Staff Report

To: Salt Lake City Historic Landmark Commission
From: Carl Leith, Senior Planner
801 535 7758 or carl.leith@slcgov.com
Date: February 4, 2016
Re: PLNHLC2016-00029 New Construction
PLNHLC2016-00027 Special Exception

NEW CONSTRUCTION – APARTMENT BUILDING

PROPERTY ADDRESS: 454-466 SOUTH TEMPLE
PARCEL ID: 1606202008, 1606202009
HISTORIC DISTRICT: South Temple Local Historic District
ZONING DISTRICT: H Historic Preservation Overlay District. R-MU (Residential/Mixed Use District)
MASTER PLAN: Central Community Master Plan
DESIGN GUIDELINES: Multi-Family

SPECIAL EXCEPTION

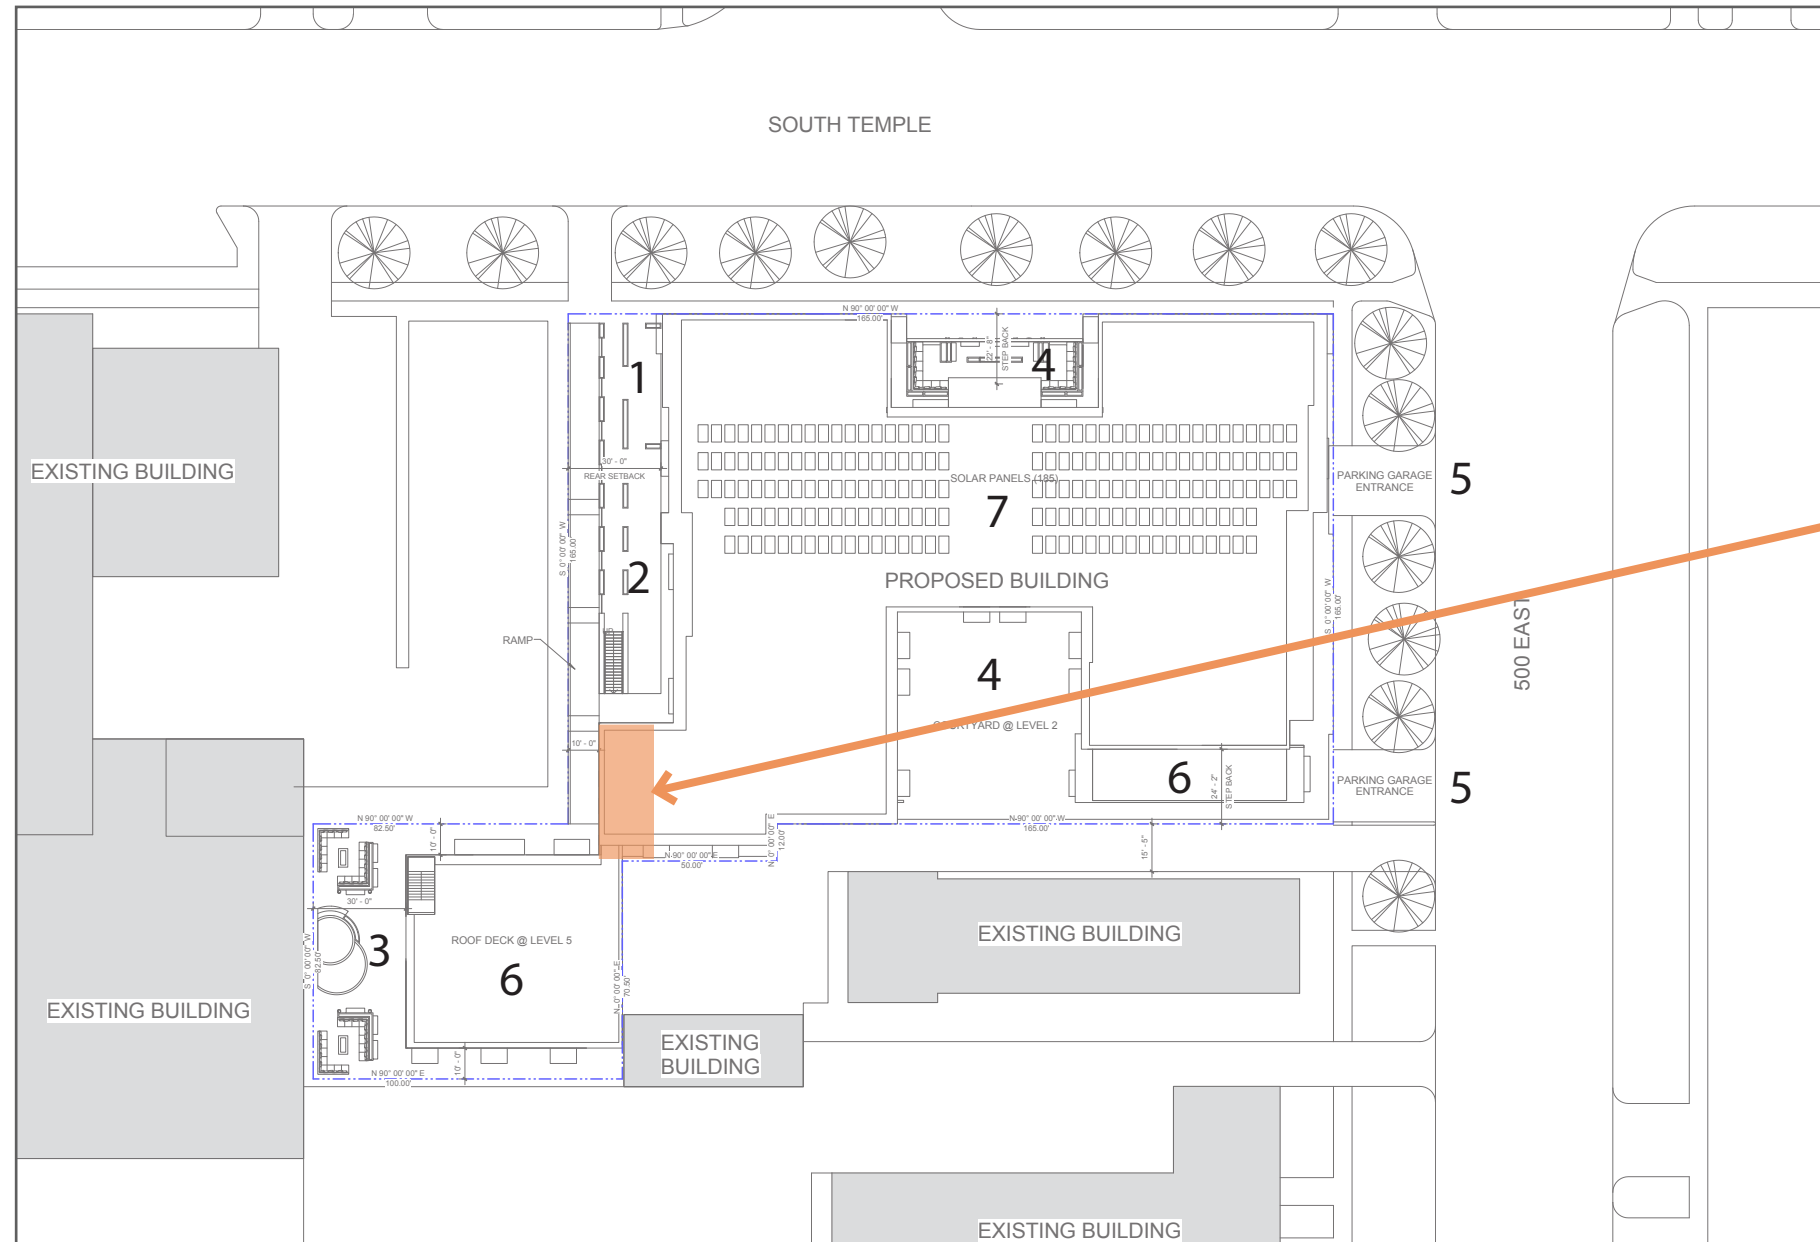
A SPECIAL EXCEPTION IS BEING REQUESTED TO ALLOW THE DEVELOPMENT ON THE SOUTHWEST CORNER OF THE PROPERTY. THIS PORTION OF THE PROPERTY IS UNDEVELOPABLE WITHOUT ALLOWING CONSTRUCTION TO OCCUR WITHIN THE REAR SETBACK OF THE 30' SETBACK ALONG THE WEST PROPERTY LINE. THERE IS A VERY NARROW OPENING BETWEEN THE TWO PROPERTIES AND WITHOUT ENCROACHING ON THE BACK OF 30' SETBACK THAT INTERIOR PIECE OF PROPERTY CANNOT BE DEVELOPED. THE ENCROACHMENT IS 20'-0" WIDE BY 42'-2" DEEP

MAIN LEVEL

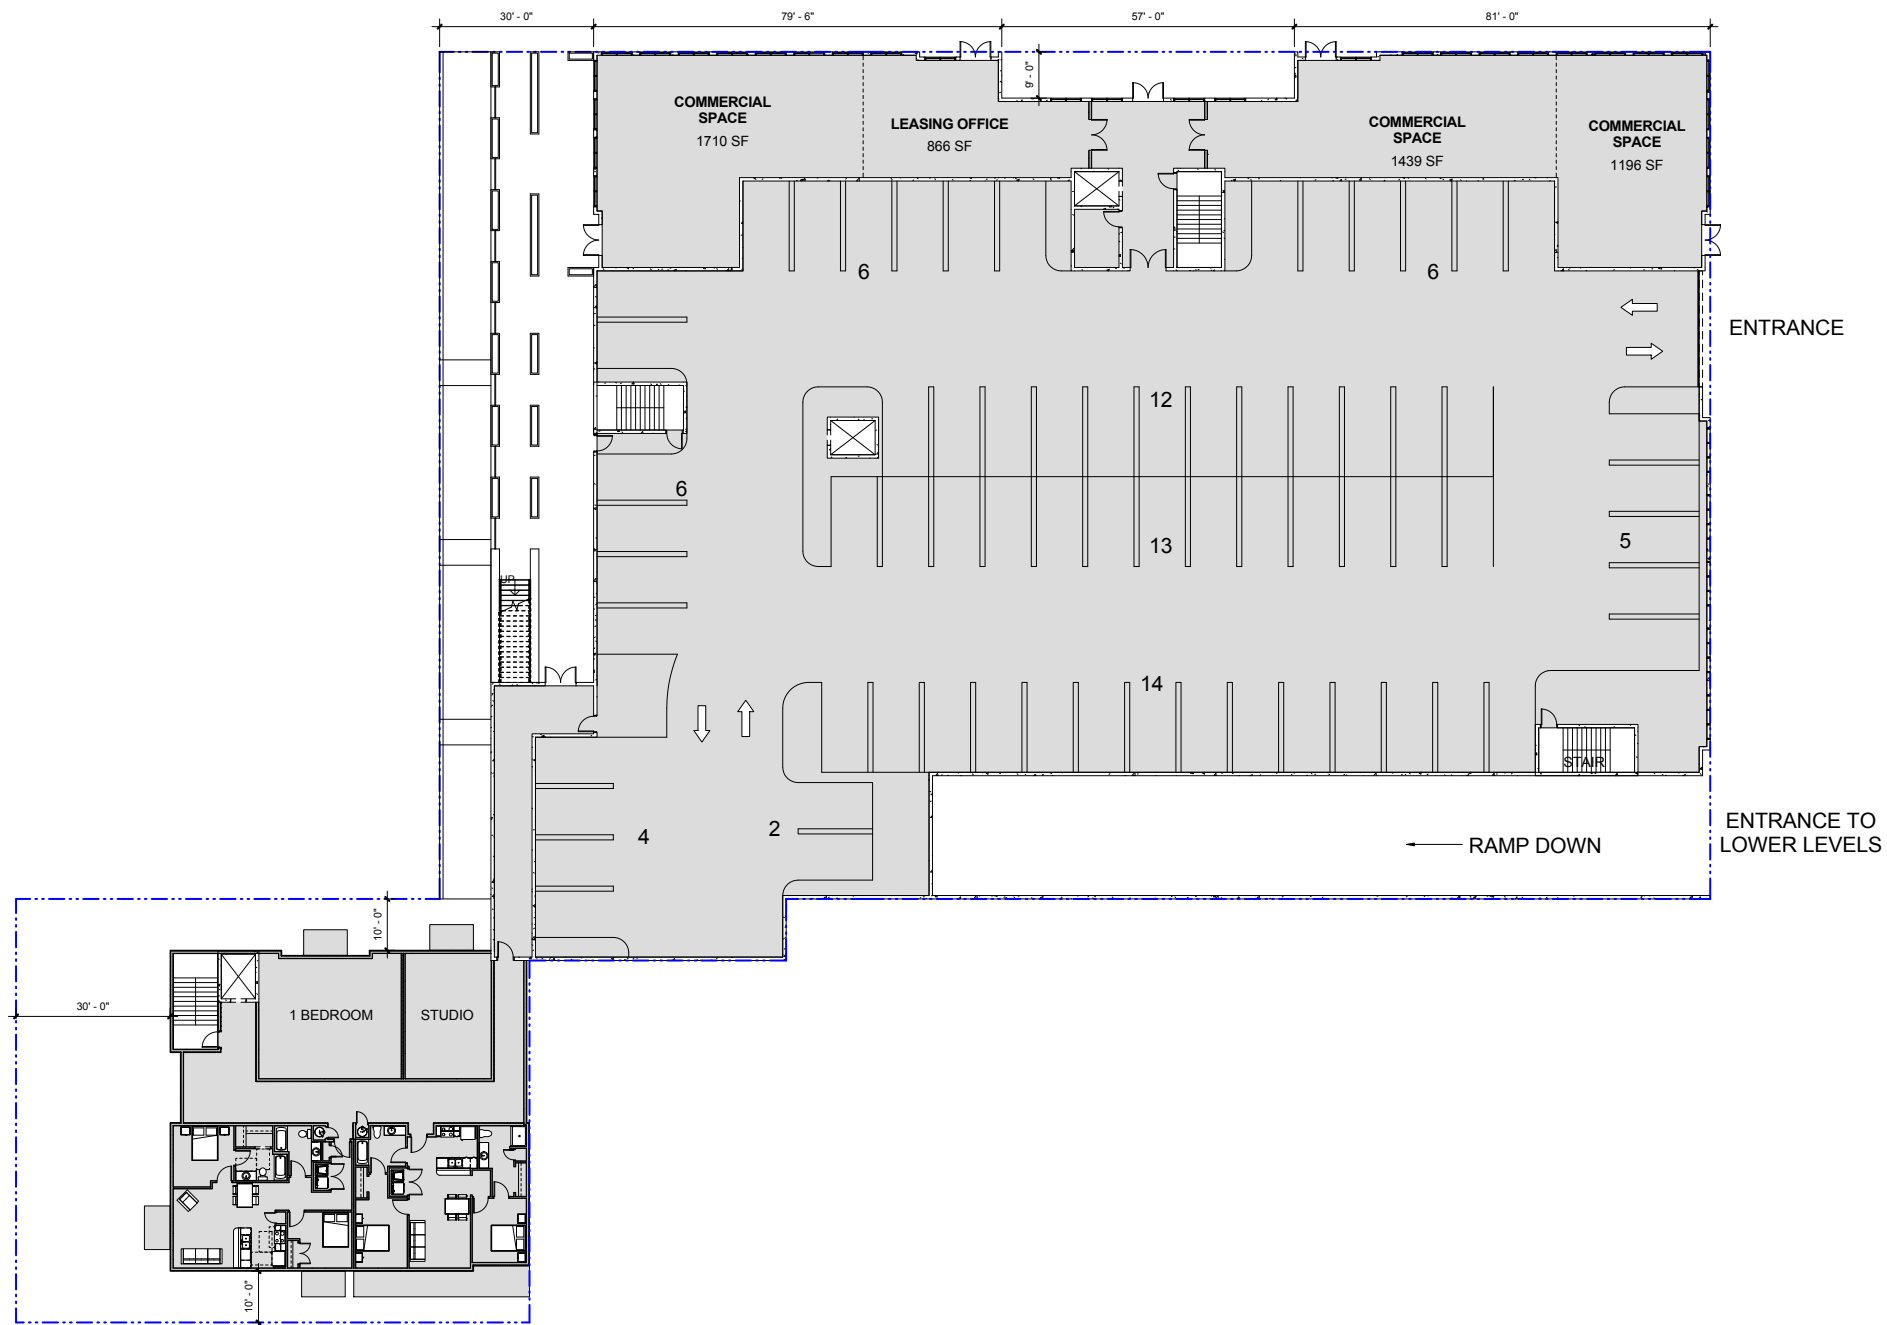
Revised the Commercial space along South Temple. We have pulled the north façade (Façade at main level only) south 3'-0" off of the South Temple property line. The entrances to the commercial spaces have been recessed 5'-0" from the property line, this helps break up the linear façade along South Temple. The changes to the commercial space will be evident in our renderings and elevations that are forthcoming. Adding up the commercial space along South Temple, we have 5,515 SF of Commercial Space.

The unit mix within the Southwest corner property has been slightly revised to help accommodate the overall reduction in building height in this area. We have reduced the total building height in this area to approx. 72'-0". This is a reduction from the previous design of 82'-0".

Along 5th East, we have revised the wall between the two vehicular entrances to incorporate more planter boxes and a 'green wall'. This will be evident in our forthcoming renderings and elevations.

There were some concerns from the commission regarding the openings along 5th east, we have revised the façade design there and now show aluminum storefront windows between the two parking entrances instead of the previous openings.

LEVEL 5

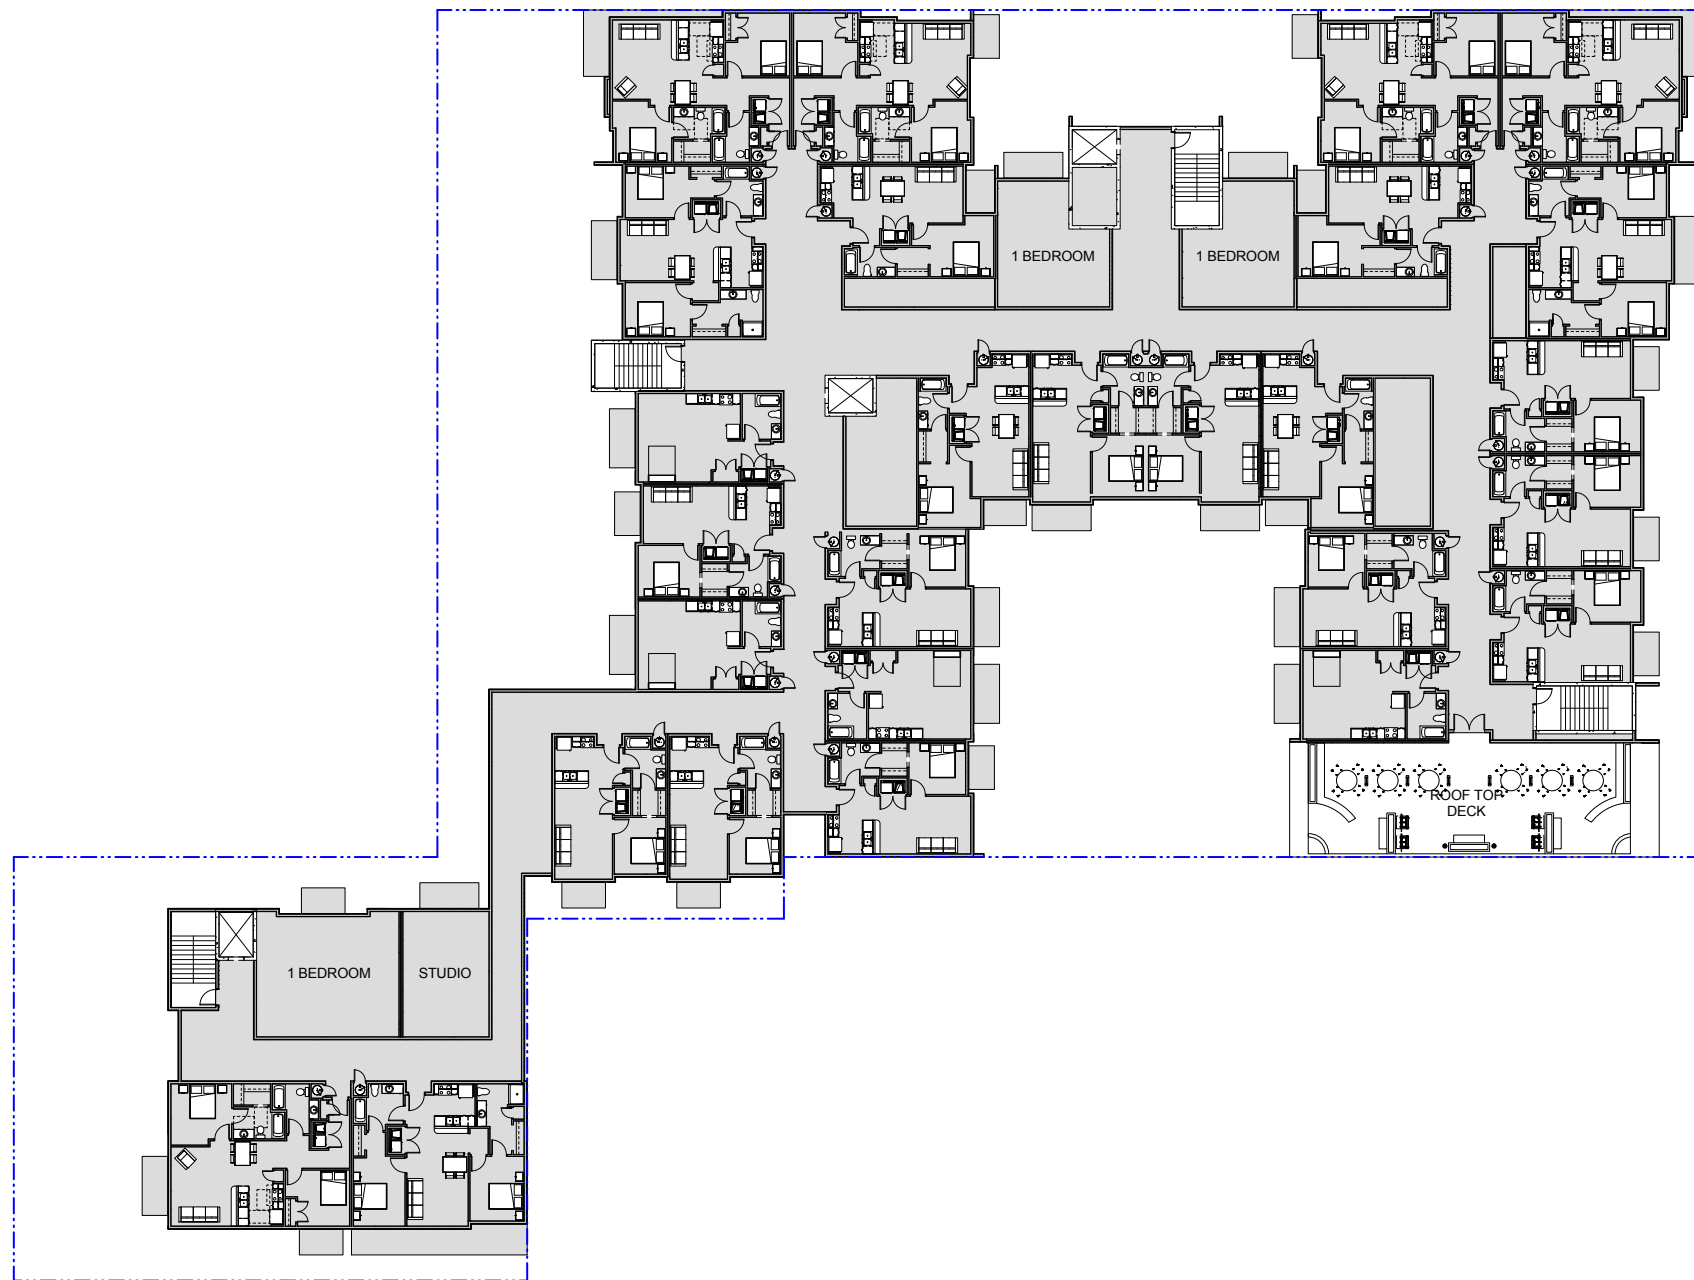
We see the roof top deck along the south property line near the Piccadilly apartments. We will provide a rendering that shows how this roof top deck will look in context with the Piccadilly apartment.

LEVEL 6

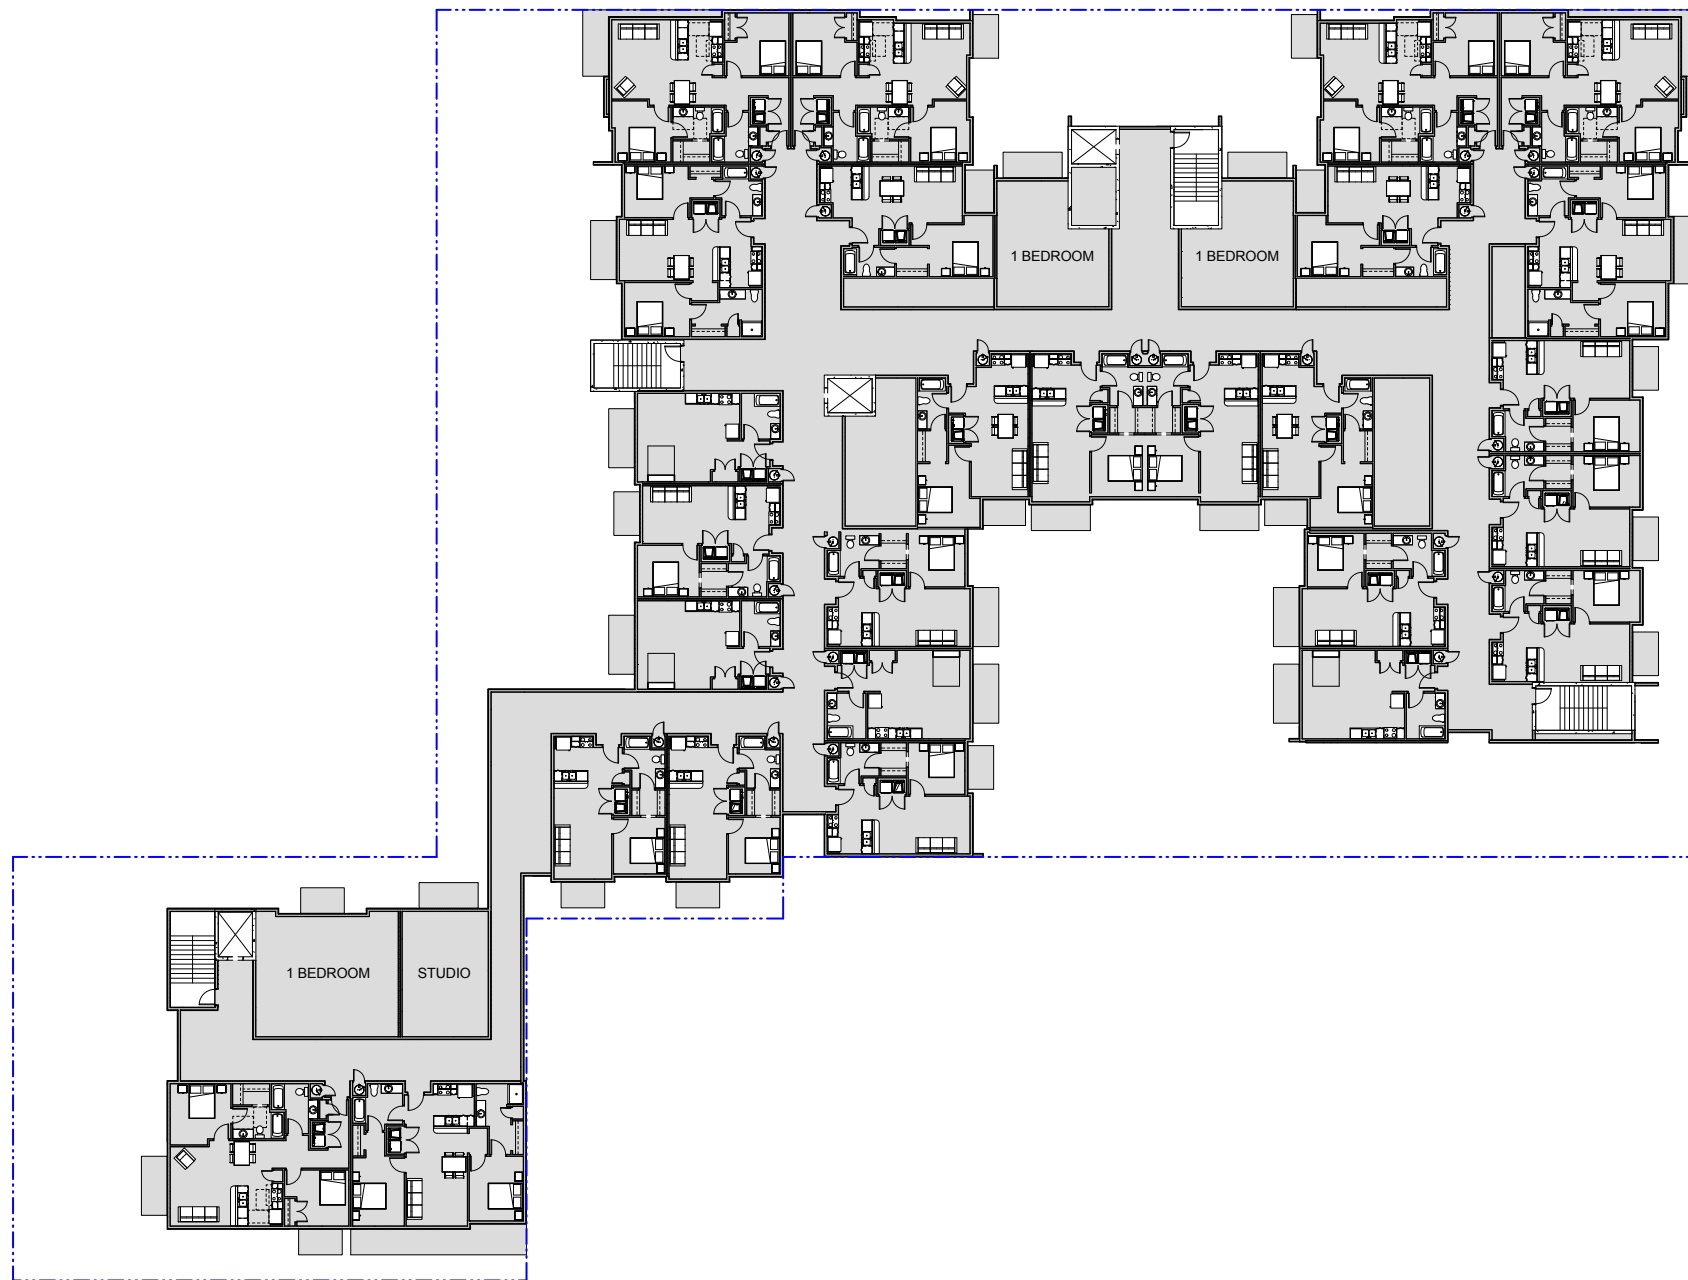
The major change here is the reduction of building height in the Southwest corner of the property. We have eliminated a floor of units in the SW and added an outdoor roof deck area. This is in response to several concerns from our HLC meeting.
